Groundwater Transfer Review Summary Form

Transfer/PA # T- <u>13314</u>				
GW Reviewer <u>Travis Brown</u> Date Review Completed: <u>11/18/2020</u>				
Summary of Enlargement (Same Source) Review:				
\Box The proposed transfer fails to keep the original place of use from receiving water from the same				
source.				
Summary of Injury Review:				
☐ The proposed transfer will result in another, existing water right not receiving previously available				
water to which it is legally entitled or result in significant interference with a surface water source.				
Summary of Similarity Review:				
☐ The proposed SW-GW transfer doesn't meet the definition of "similarly" as per OAR 690-380-2130.				
This is only a summary. Documentation is attached and should be read thoroughly to understand the				
basis for determinations.

Ground Water Review Form:					
☐ Water Right Transfer					
☐ Permit Amendment					
⊠ GR Modification					
\square Other					
Applicant Name: <u>City of Salem</u>

Well Location Map

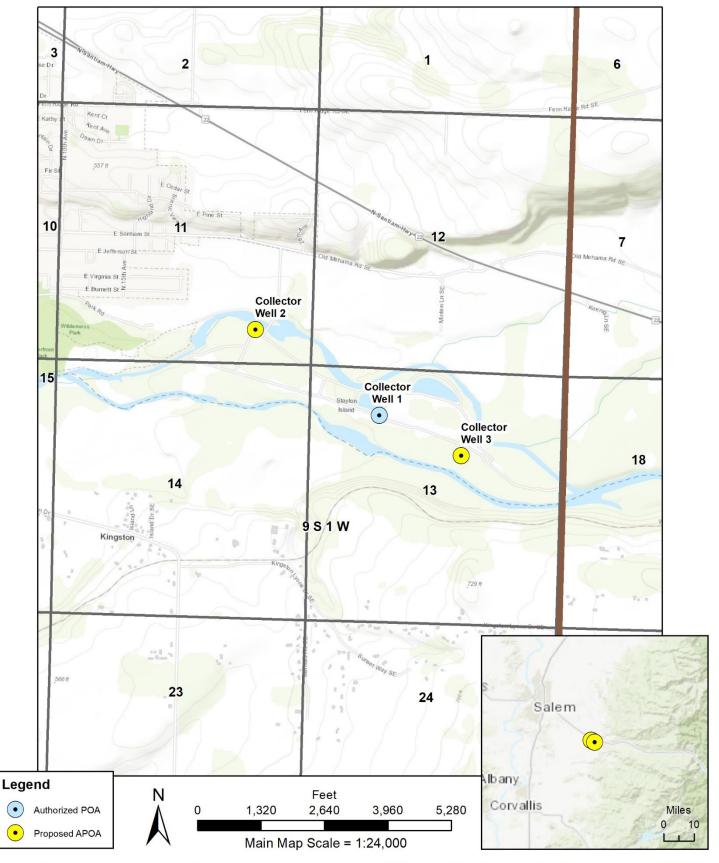
2.	Will the proposed POA develop the same aquifer (source) as the existing authorized POA? Yes No Comments: The current POA ("Collector Well 1"/LINN 2676) is ~12.5 ft deep and produces from the saturated alluvium underlying and adjacent to the North Santiam River. The proposed APOA will be nearby and will be less than 50 ft deep.
